**VILLAGE OF LOMBARD**  
**INTER-DEPARTMENTAL REVIEW GROUP REPORT**

**ZBA 04-01; 338 W. View Street**: The petitioner requests that the Village take the following actions for the subject property located within the R2 Single-Family Residence District:

1. Approve a variation from Section 155.406 (E) of the Zoning Ordinance to reduce the minimum required lot width from 60 feet to 47.5 feet;
2. Approve a variation from Section 155.406 (F) (1) of the Zoning Ordinance to reduce the minimum required front yard setback from 30 feet to 27 feet to allow for an addition and front deck; and
3. Approve a variation from Section 155.406 (F) (1) of the Zoning Ordinance to reduce the minimum required front yard setback from 30 feet to 25 feet to allow for bay window.

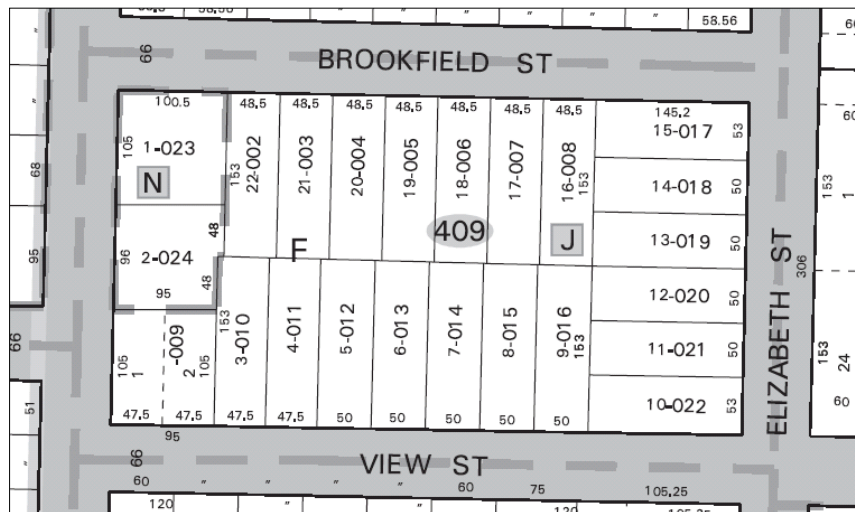
The Fire Department/Bureau of Inspectional Services has the following comments:

- The existing structure and supports must be removed in their entirety and the new addition must have a full concrete foundation and footing installed per code.
- The new addition must meet all current Village building codes.

**Existing Conditions**

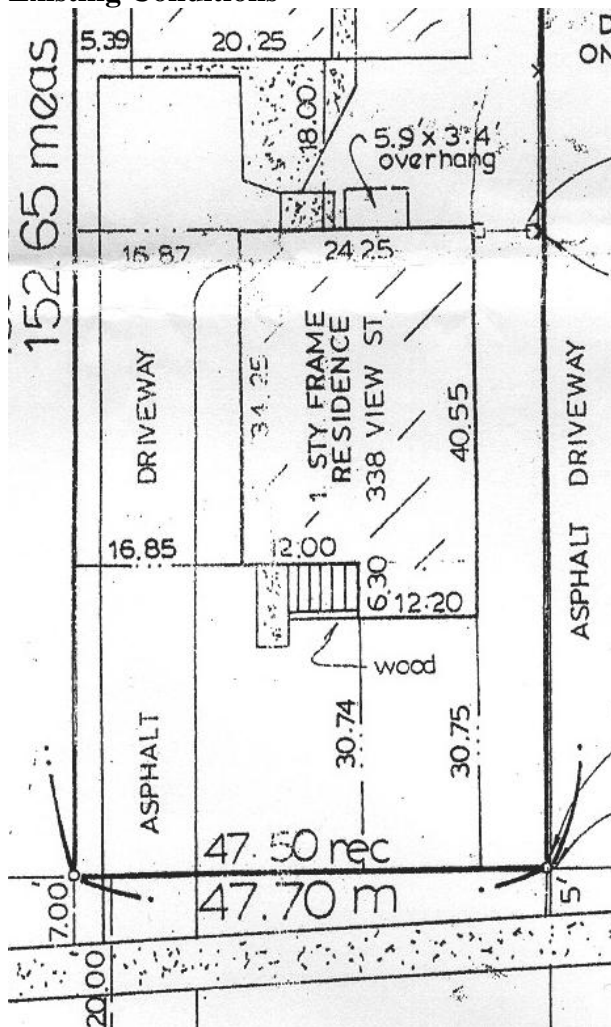
The Zoning Ordinance does not permit the petitioner from expanding the front of the house. The enclosed porch and stairway could be replaced with a 6.5-foot by 24-foot addition, which would add the desired additional living space. Also, in 2002, the Zoning Ordinance was modified to allow unenclosed, roofed-over front porches as a permitted obstruction within the front yard (provided that the porch is not more than 7 feet deep and maintains a minimum 25-foot setback).

The illustrations below show the existing conditions on the property and demonstrate potential improvements the petitioner could make. These improvements would not require any setback relief from the Zoning Ordinance (assuming the variation for a 47.5-foot wide lot is granted).
